**MEMORANDUM**

**Case # 15-05**

**SUBJECT:** Proposed Revisions to Section 616 Reclaimed Water Line Construction and NEW Reclaimed Valve Box detail

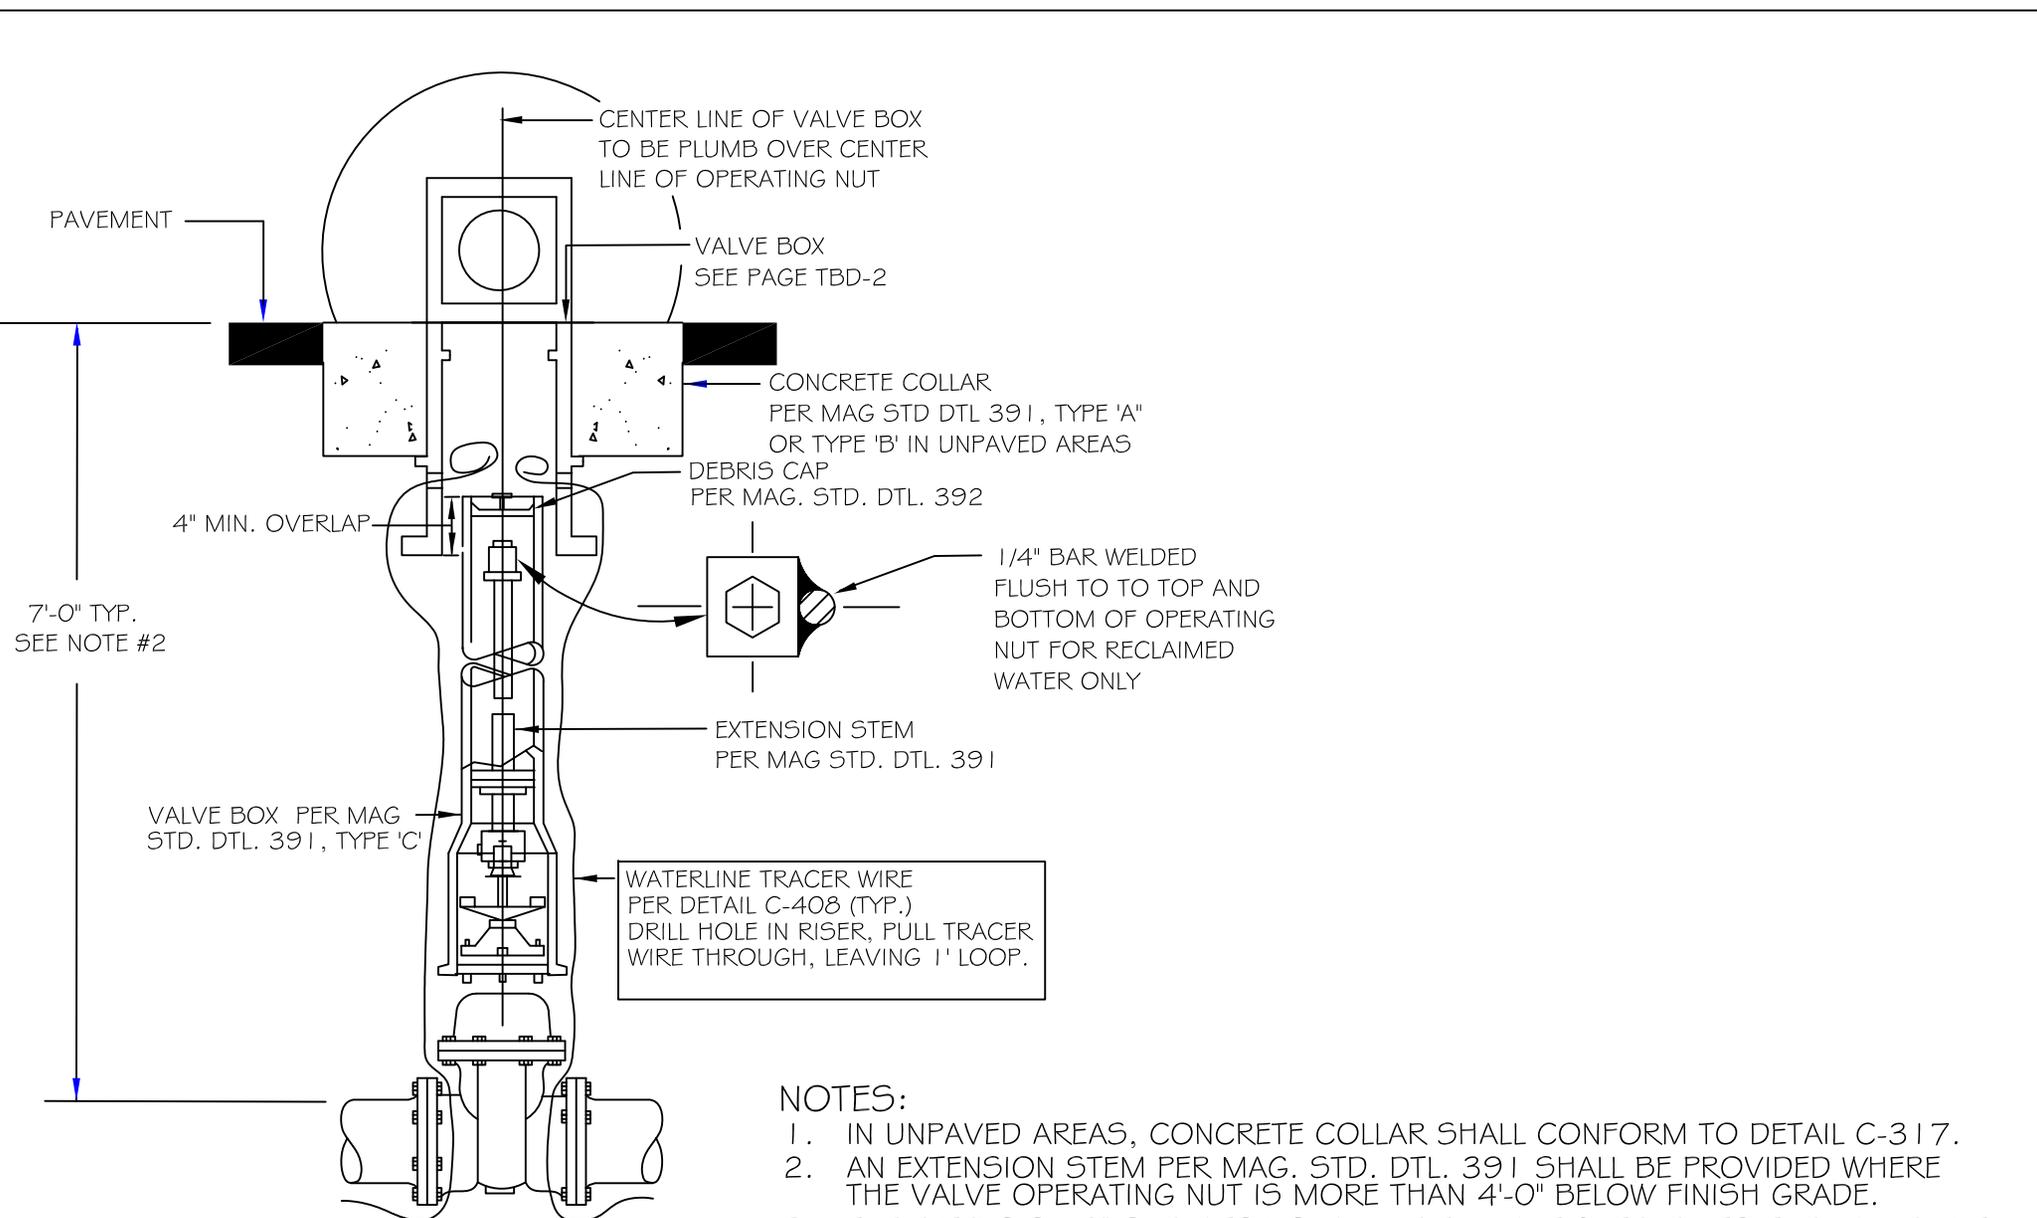
Valve boxes shall be in accordance with Section 345, this Section and Detail 391-1, ~~and 391-2~~ and TBD.  
Manholes shall be in accordance with Section 625, 787 and this Section, and applicable Details.

DETAIL NO. <b>TBD- 2</b>	 <b>MARICOPA ASSOCIATION of GOVERNMENTS</b> STANDARD DETAIL <b>ENGLISH</b>	<b>RECLAIMED WATER VALVE BOX INSTALLATION</b>	REVISED 3/4/15 Draft	DETAIL NO. <b>TBD- 2</b>
-----------------------------	---	---	-------------------------	-----------------------------

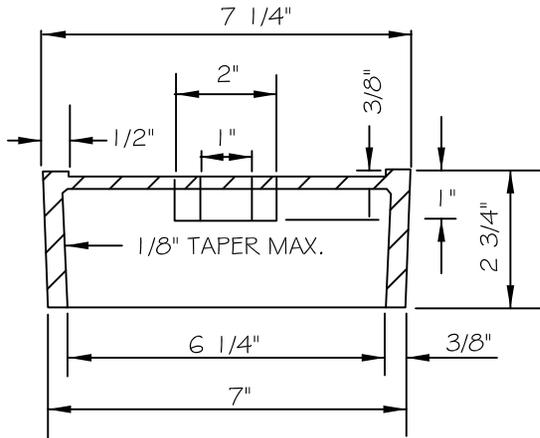
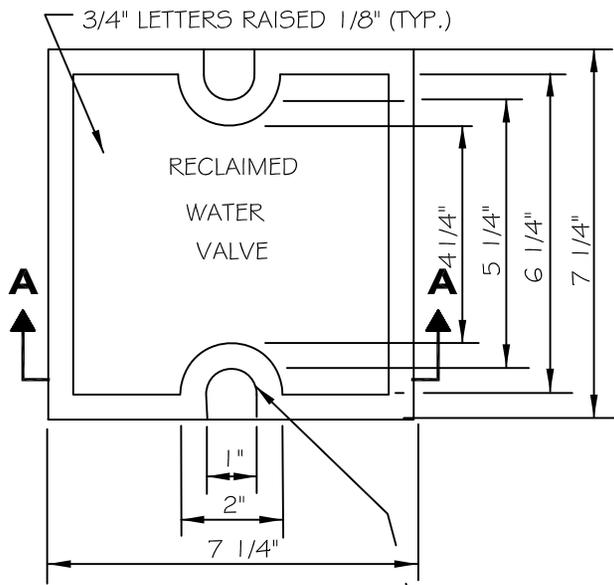
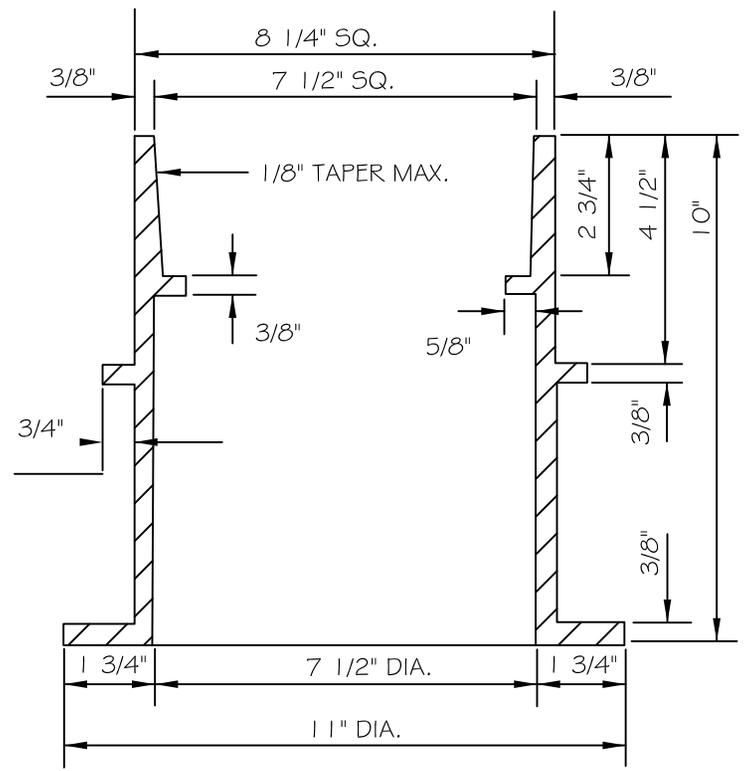
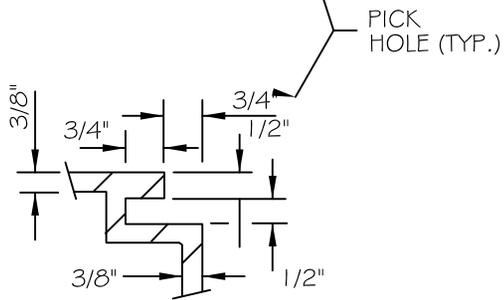
2. New Reclaimed Valve Box Detail No. TBD

See attached initial DRAFT for further development.
